Revise the Beaver Valley Power Station, Unit No.2
Proposed technical Specification Change No. 47

Beaver Valley Power Station, Unit No. 2
Proposed Technical Specification Change No. 47
REVISION OF TECHNICAL SPECIFICATION 4.3.2.1.1

ATTACHMENT B-1
Beaver Valley Power Station, Unit No. 2
Proposed Technical Specification Change No. 47
Equipment Testing Requirements Evaluation

TABLE 4.3-2

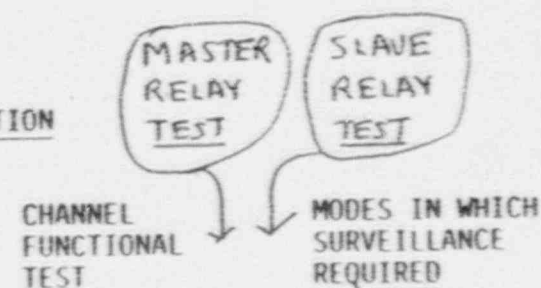
REPLACE
WITH
"A"

TABLE 4.3-2 (Continued)

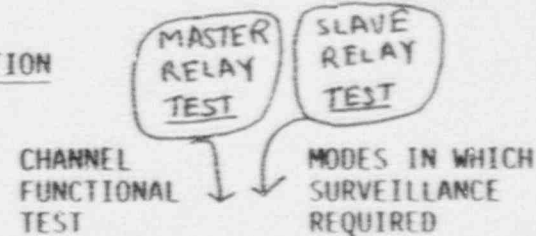
REPLACE WITH INSERT "C"
